GROVE & DALL'OLIO  
ARCHITECTS PLLC

**MEMORANDUM**

**Re: Charles Washington Hall**  
ADDENDUM No. 2

The following information amends or supersedes the Project Manual dated October 28, 2014, Architectural drawings dated October 22, 2014, Landscape Drawings dated October 14, 2014, structural and MEP drawings dated September 26, 2014 and Addendum No. 1 dated November 11, 2014.

SK  
1

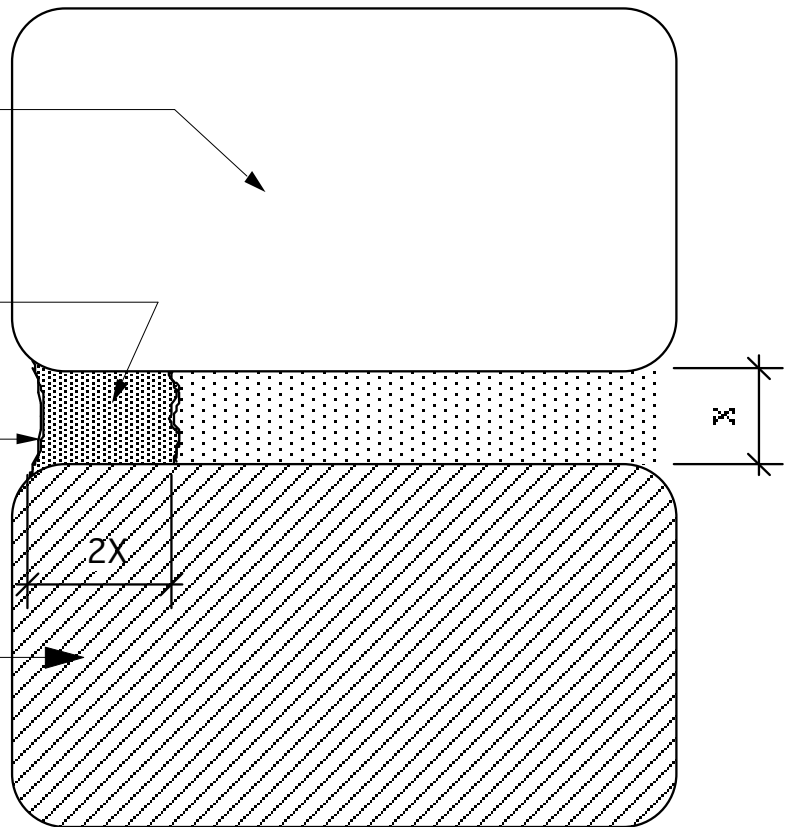
4. Masonry pointing limits or extents have not been established. The specifications are performance based. Pointing will be incidental, as needed, on this project. The majority of walls (other than the south wall) observed by the design team are in good condition. The building is available for inspection by masonry contractors. For further clarification of when a joint should be pointed, see attached SK 1.

Rake out only loose  
mortar. After raking,  
repoint only if joint depth  
is greater than 3/8".

New pointing mortar  
w/shallow concave  
joint.

Replace spauling  
or damaged brick.
